TECHNICAL BULLETIN

RUPES HLR21

Ibrid Random Orbital Polisher

Technical updates on motor body and rotor bearing

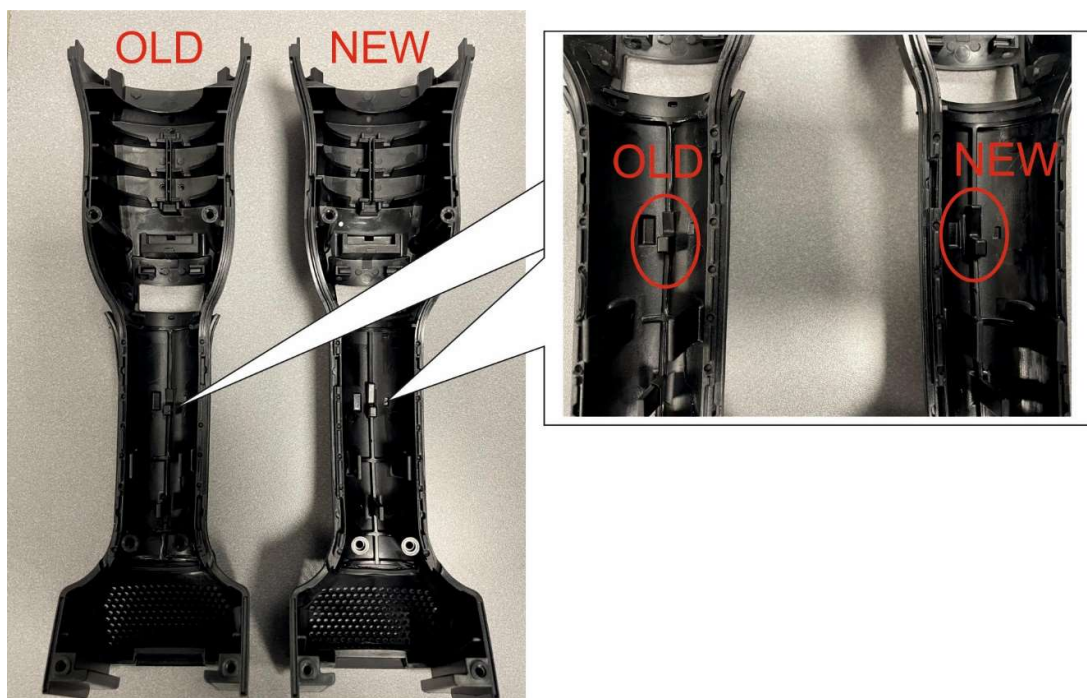
- Replace of motor body both for the lower part 31.396/C and the upper part 311.396/C
- New rotor bearing with o-ring (cod 9.579)
- Remove rubber bearing cover (cod 268.400)

During the assembly of the tool it is important to fix and tighten the screws of the gearbox first, then tighten the screws of the motor body.
